Errata Sheet

Product Family:	DL305	Date:	10/14/2021
Manual Number	D3-350-M		
Revision and Date	2nd Edition, Rev. D; March 2010

Changes to Chapter 5. Standard RLL Instructions; Math Instructions; Multiply Double (MULD)

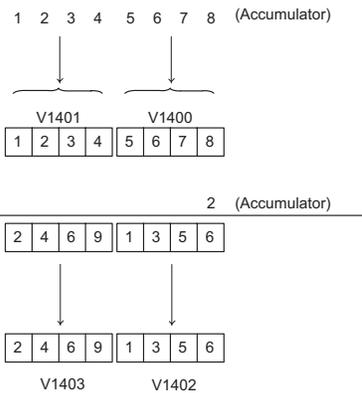
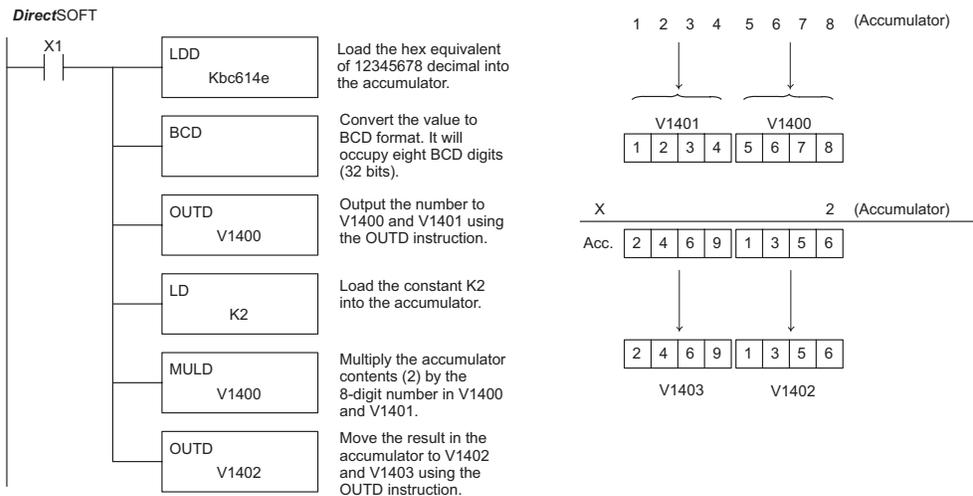
Page 5-84. The ladder example shown is incorrect. Replace it with the following example.

Reset the PLC to Factory Defaults

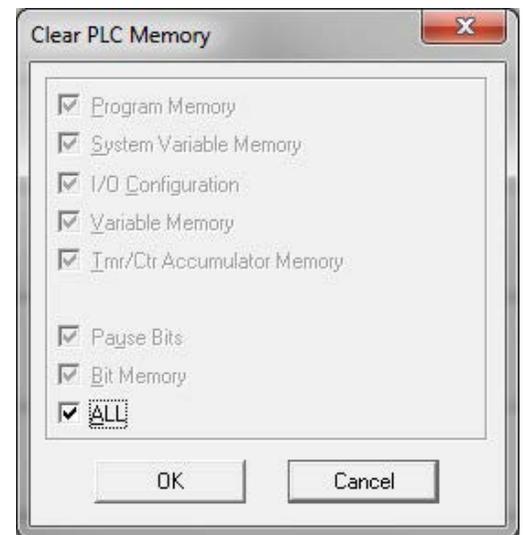
Page 9-25. Add the following to the end of this chapter (right after Regular Forcing with Direct Access):

Step 1 – While connected to the PLC with DirectSoft, go to the PLC menu and select; "Clear PLC Memory". Check the "ALL" box at the bottom of the list and press "OK".

Step 2 – While connected with DirectSoft, go the PLC menu and then to the "Setup" submenu and select "Initialize Scratch Pad". Press "Ok".
